**SUBJECT: Thunder Spirit Wind Energy Project, Adams County, ND (Case No. PU-11-601)**

**AMENDMENT to the North Dakota Public Service Commission  
for a Certificate of Site Compatibility**

**Case No.: PU-11-601**

***AUGUST 2013***

Figure A  
**Turbine Adjustments**  
**(After June 4, 2013 PSC Filing)**

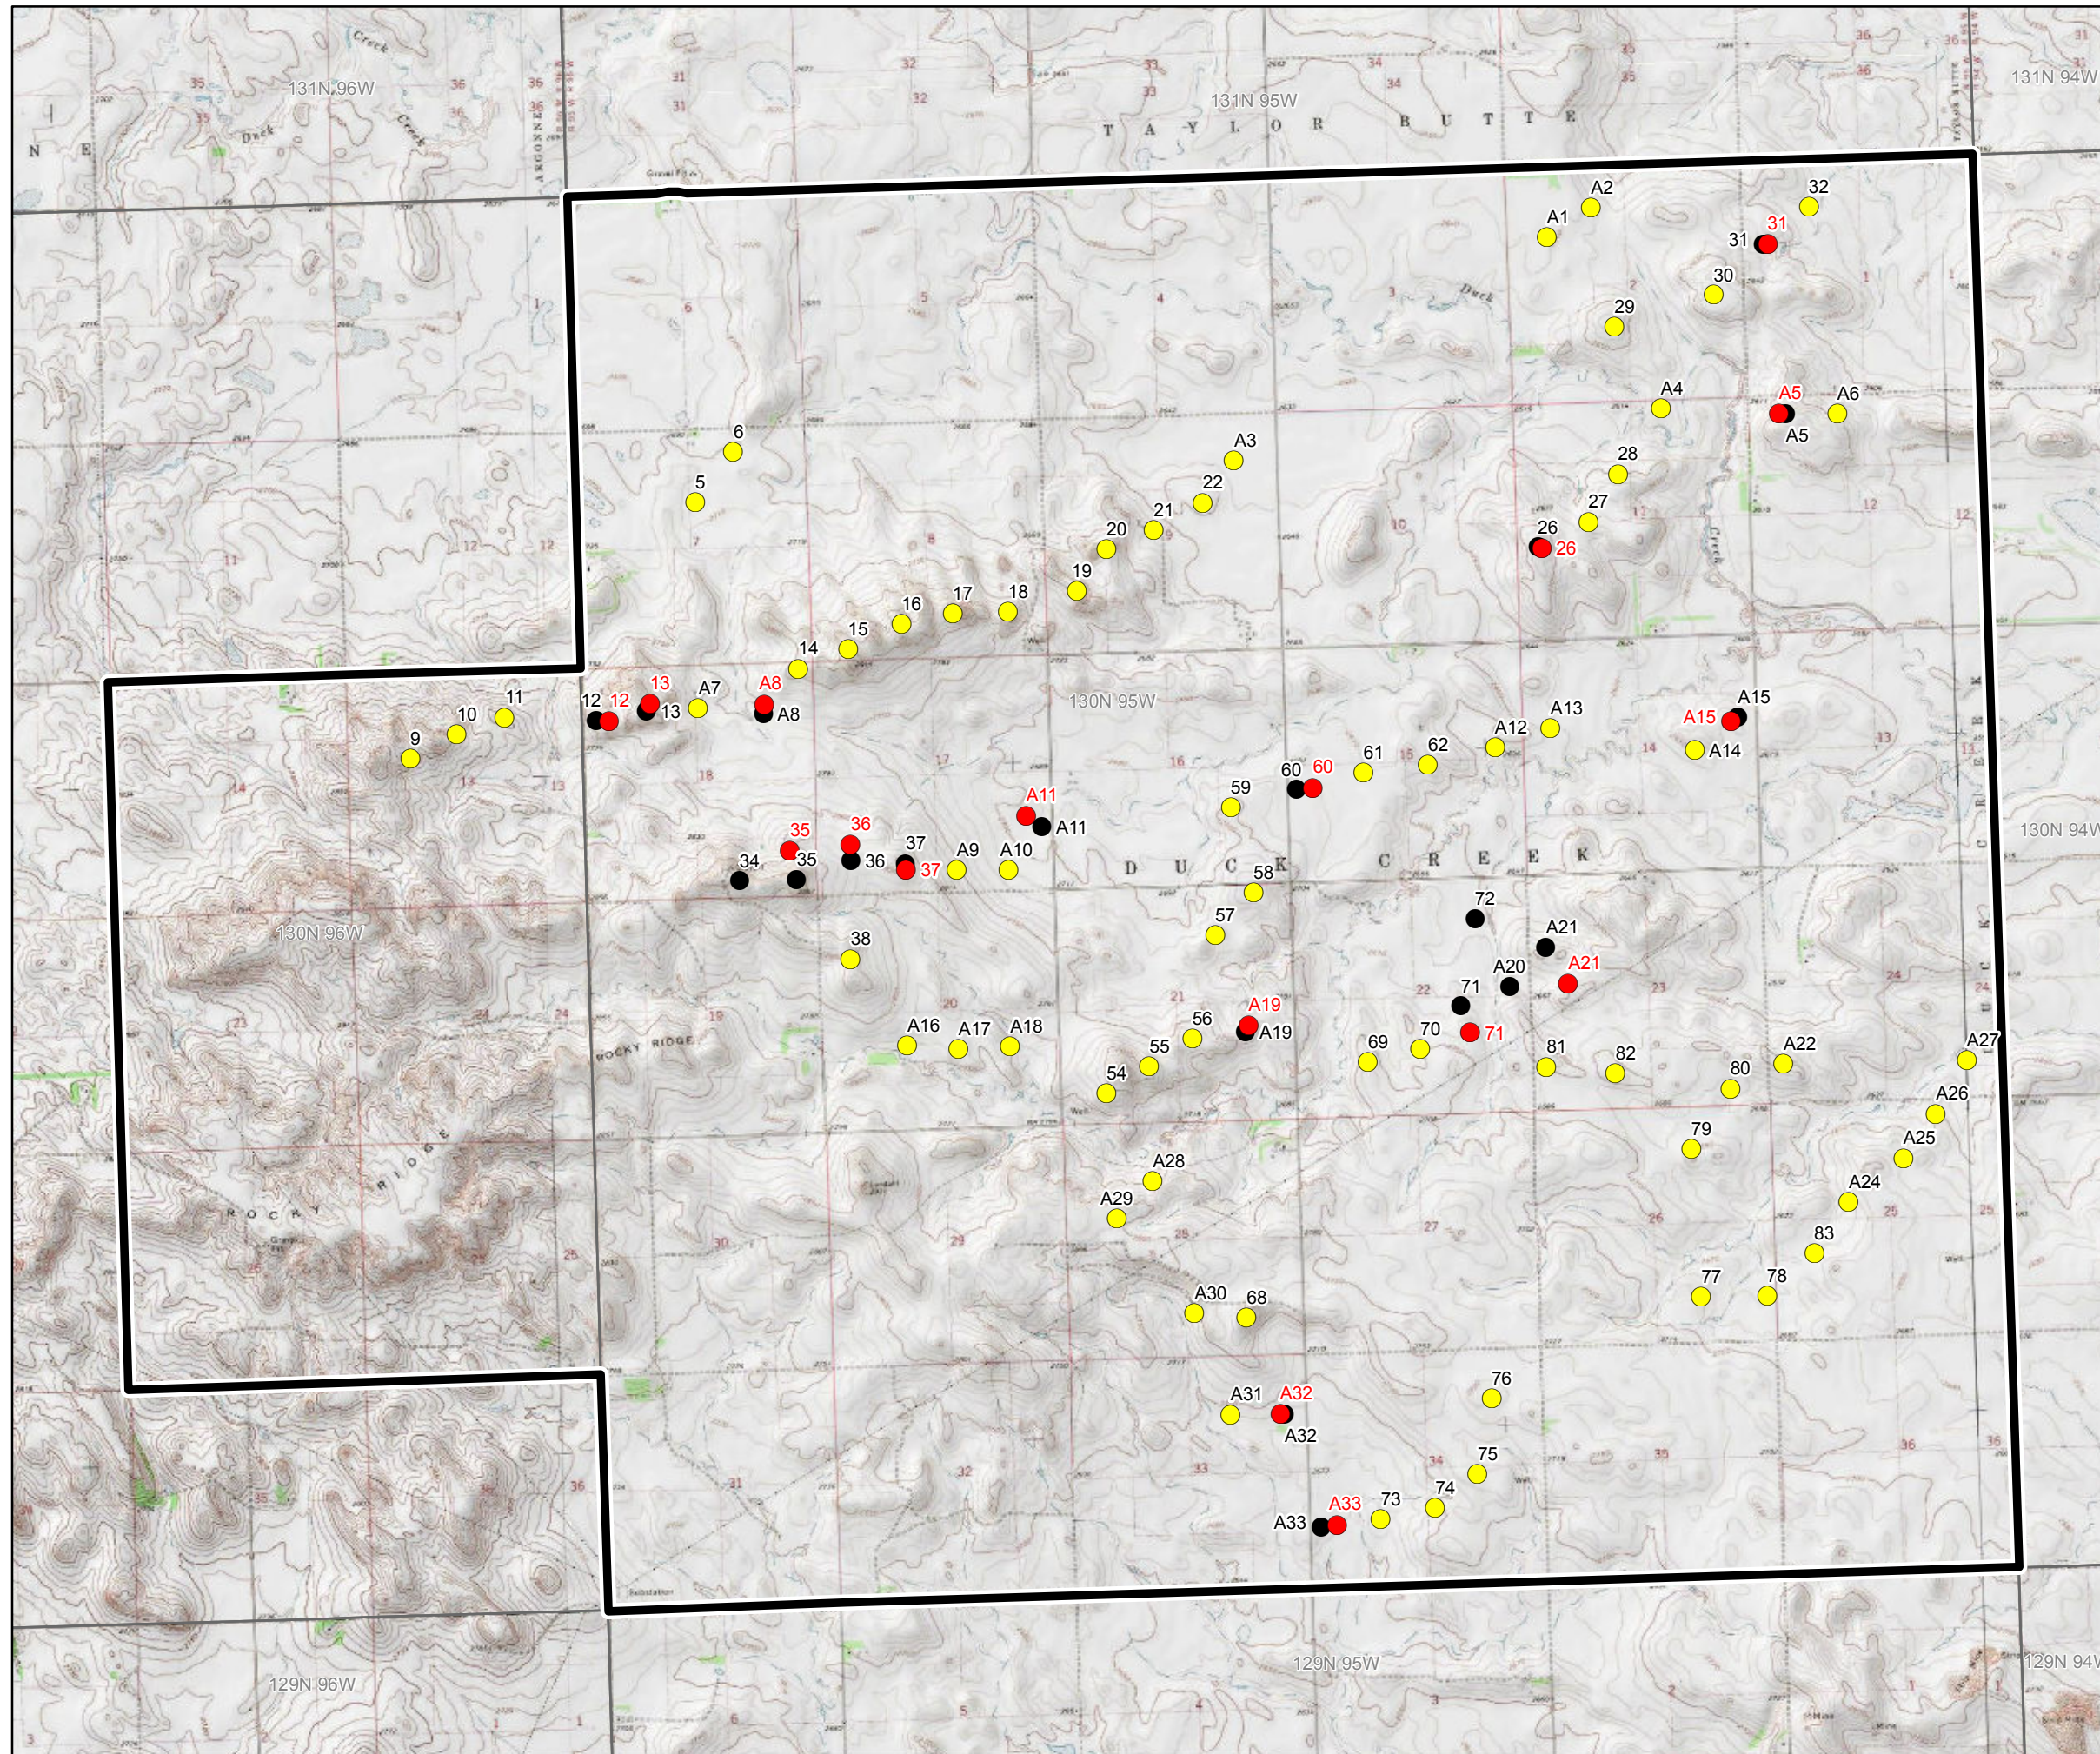
The table below lists the turbines that were moved and the old and new distance to the nearest receptor. Figure A shows the turbine relocations and differentiates between the locations submitted as part of the Application and the revised locations. Tables summarizing impacts (or lack thereof) relating to the latest round of layout adjustments are also included in this Amendment in the following section.
